Access Compliance Report

Public Rights-of-Way

(Curb Ramps)

Intersection ID: 4445	Main Street: DASHIEL_DR	Cross Street: SILVER_GLEN_LN	Location: S
ADA ID: BFB9944711B2	Ramp Type: Perp	Initial Pass/Fail: Pass	Overall Compliance: No
Severity Score: 10			
Codes/Mitigation Info/Possible Solution		Field Measurements/Component Compliance

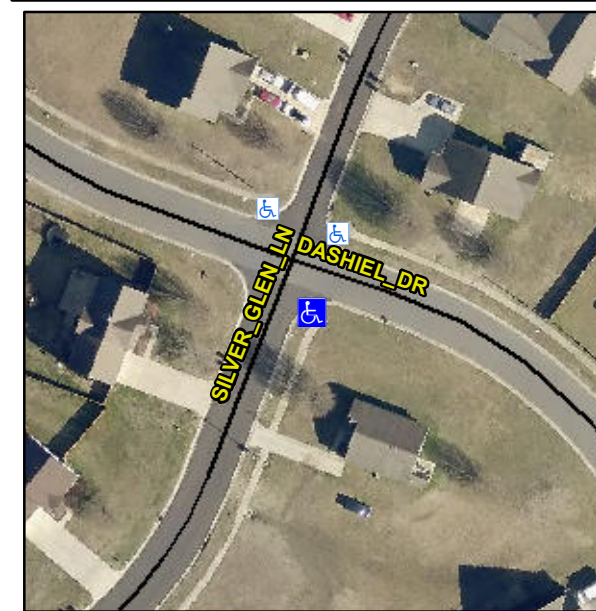
**R304.2.2-Perp, R304.3.2-Para,
R304.5.3, R305**

Compliance	Description	Data	Compliance	Description	Data
N/A	Ramp Length (in)	79.0	Yes	Ramp Slope (%)	5.5
Yes	Ramp Width (in)	54.0	Yes	Ramp XSlope (%)	0.8
N/A	Flare Type LT	Sloped	N/A	Flare Type RT	N/A
N/A	Flare Slope LT (%)	10.1	N/A	Flare Slope RT (%)	2.8
N/A	Flare Traversable LT?	No	N/A	Flare Traversable RT?	No
Yes	Landing Length (in)	51.0	No	DWS Provided?	No
Yes	Landing Width (in)	88.0	N/A	DWS Contrast?	No
No	Landing Slope (%)	2.9	N/A	DWS Length (in)	N/A
No	Landing X Slope (%)	3.8	N/A	DWS Full Width?	No
N/A	Landing Curb? (Y/N)	No	N/A	DWS Offset (in)	N/A
N/A	Shared Landing?	No			
Yes	Gutter Ponding?	No	Yes	Gutter Slope (%)	4.2
Yes	Gutter Lip Ht (in)	0.0	No	Gutter X Slope (%)	3.3
N/A	Painted X Walk1?	No	N/A	Painted X Walk2?	N/A
	X Walk 1 Direction	To NE		X Walk 2 Direction	N/A
N/A	X Walk 1 Width (in)	N/A	N/A	X Walk 2 Width (in)	N/A
	X Walk 1 Slope (%)	5.1		X Walk 2 Slope (%)	N/A
	X Walk 1 X Slope (%)	2.4		X Walk 2 X Slope (%)	N/A

N/A	Ramp inside XWalk1?	N/A	N/A	Ramp inside XWalk2?	N/A
	Road Slope (%)	N/A	N/A	Clear Space?	Yes
	Road X Slope (%)	N/A	N/A	Clear Space to XWalk (in)	N/A
Yes	Any Obstructions?	No	Yes	Storm Grate/Utility Hazard?	No
	Obstruction Type			Storm Grate/Utility Type	
		N/A			N/A
			Yes	Surface Condition? (G/P)	Good

**Remove & Replace Entire Ramp.
Remove & Replace Gutter.**
